For ATCB Comments 050408

For ATCB Comments 052808

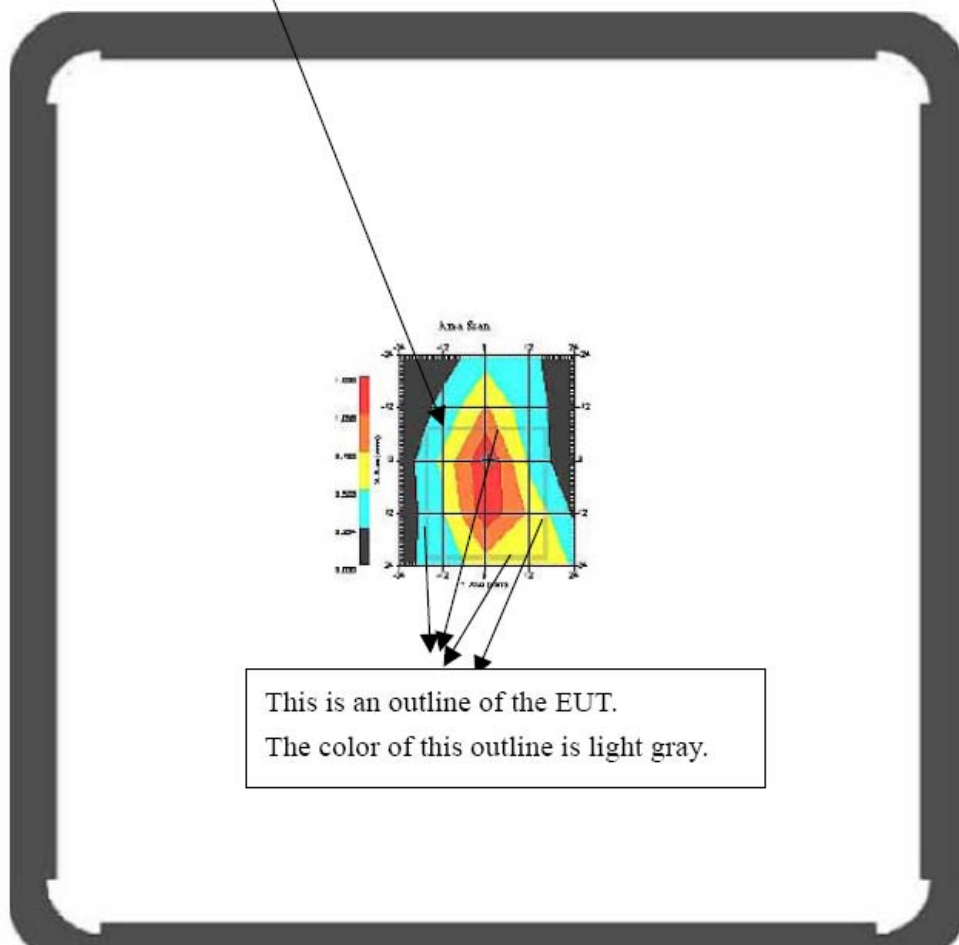
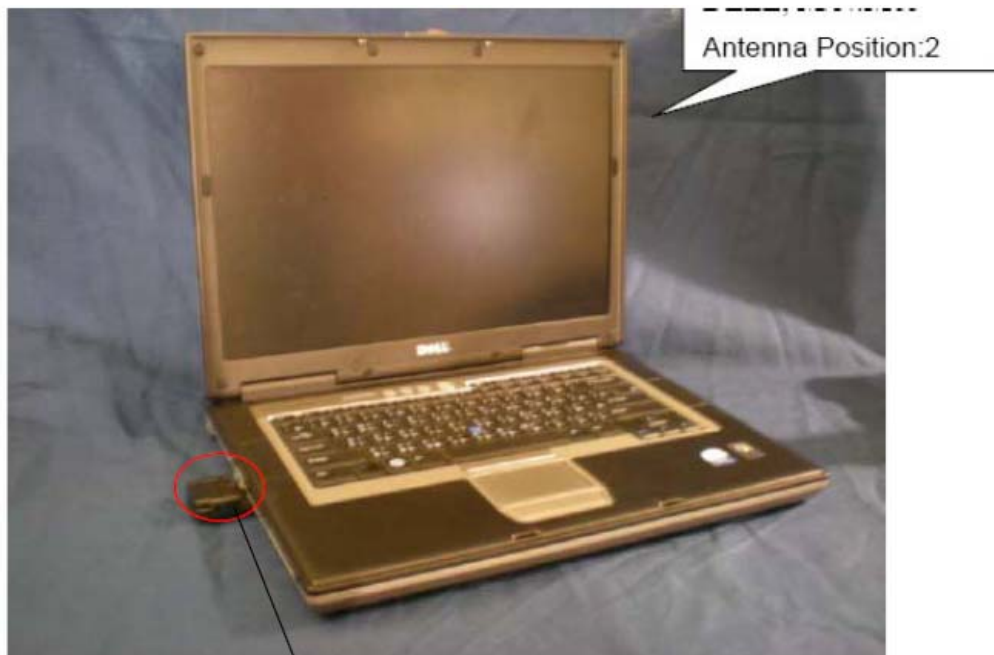
6) FCC desires the outline of the device to be shown for relative positioning on the plots. This does not appear to be done. Currently it can not be determined whether it is the module or antenna where the hot spots occur. Please update.

QTK: Our report shows relative positioning on the plots such as the photos as below.
